Determination 2009/18

Dispute about the number of sanitary fixtures to be provided for a warehouse at 19 Gerald Connolly Place, Sockburn, Christchurch

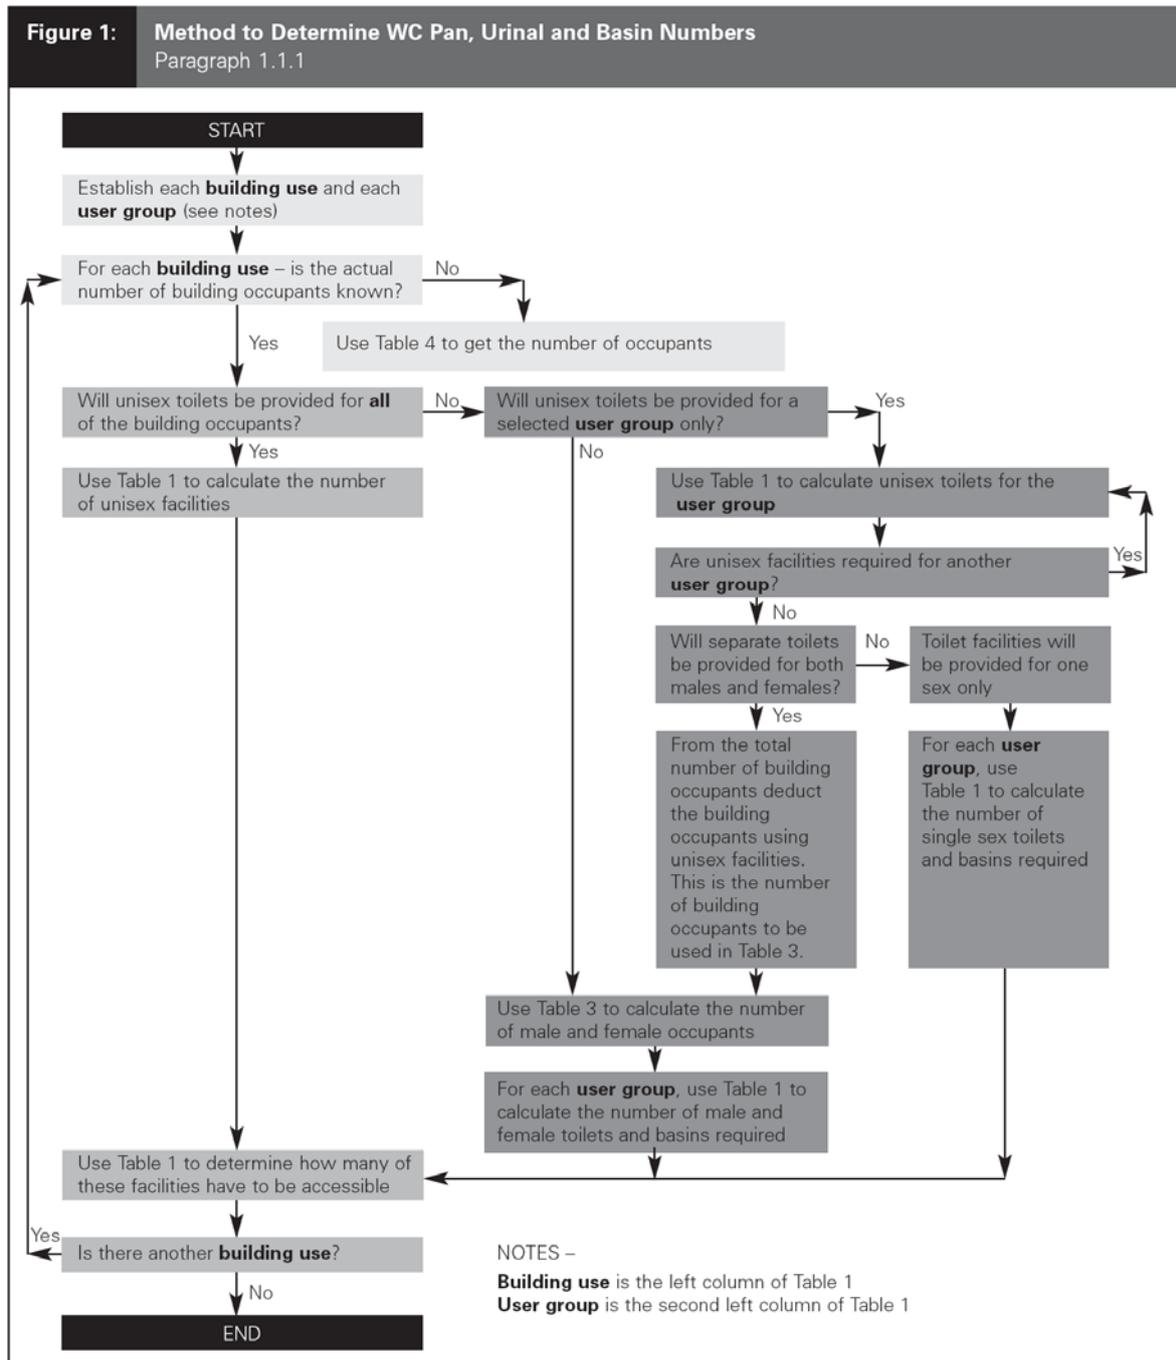
- 6.6 Figure 1 of G1/AS1 sets out the methods to determine the number of sanitary fixtures required in a building relating to the number of building occupants for the use of the building. Figure 1 provides two methods to do this:

1. where the actual number of occupants is known
 2. where the number of occupants is not known.
- (The second method relies on the use of Table 4 of G1/AS1, which is adopted from C/AS1 Part 2.)

- 6.7 The applicants know the actual number of occupants and have applied the first method. The authority says that the second method must be used.

- 6.8 The applicant has submitted that only 3 persons will be employed in the building. Accordingly, I accept this as being “the actual number of building occupants”. The building has a single use.
- 6.9 With the number of occupants known and with unisex facilities to be provided for all staff, Figure 1 refers to Table 1 to determine the number of sanitary fixtures to be provided. Table 1, under “Commercial, Staff facilities . . .”, says that one unisex toilet facility is required for between 1 to 5 staff (the facility is to be accessible).

- 6.10 The building has a floor area of 3,600 m², and the occupancy density from Table 4 for “warehouse storage” is 0.03. This gives a maximum occupant density for the building of 108 people. Again, assuming unisex facilities, Table 1 requires 4 such facilities, with one being accessible. This number exceeds the authority’s stated position of three unisex facilities, one being accessible.

- 6.11 The building is to be used for the bulk storage of milk powder and populated by a limited number of employees. In my opinion the calculated occupancy is grossly unrealistic.
- 6.12 The actual occupancy numbers for the building is known. It is therefore appropriate for the applicant to use the first method from Figure 1, as described above. I conclude that the provision of one unisex accessible facility is sufficient to meet the requirements G1/AS1, and hence the requirements of Clause G1.
- 6.13 I note that, in this instance, there are also other sanitary facilities available in adjacent buildings on the same site in which the building is located.

- 7.1 In accordance with section 188 of the Act I determine that the provision of only one unisex accessible toilet is necessary for the warehouse to comply with Building Code Clause G1 Personal hygiene.
